UNITED STATES PATENT AND TRADEMARK OFFICE

APPLICATION NO.	FILING DATE	FIRST NAMED INVENTOR	ATTORNEY DOCKET NO.	CONFIRMATION NO.
10/720,138	11/25/2003	Mei-Ling Liu	LIUM3007/EM	4425

Office Action Summary

DETAILED ACTION

FIG. 7
PRIOR ART

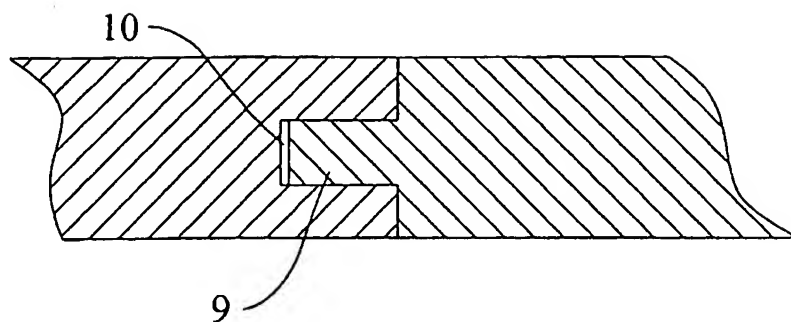
The drawings are objected to under 37 CFR 1.83(a). The drawings must show every feature of the invention specified in the claims. Therefore, the "longitudinal notch having a upper side and a long lower side" must be shown or the feature(s) canceled from the claim(s). No new matter should be entered.

Corrected drawing sheets in compliance with 37 CFR 1.121(d) are required in reply to the Office action to avoid abandonment of the application. Any amended replacement drawing sheet should include all of the figures appearing on the immediate prior version of the sheet, even if only one figure is being amended. The figure or figure number of an amended drawing should not be labeled as "amended." If a drawing figure is to be canceled, the appropriate figure must be removed from the replacement sheet, and where necessary, the remaining figures must be renumbered and appropriate changes made to the brief description of the several views of the drawings for consistency. Additional replacement sheets may be necessary to show the renumbering of the remaining figures. Each drawing sheet submitted after the filing date of an application must be labeled in the top margin as either "Replacement Sheet" or "New Sheet" pursuant to 37 CFR 1.121(d). If the changes are not accepted by the examiner,
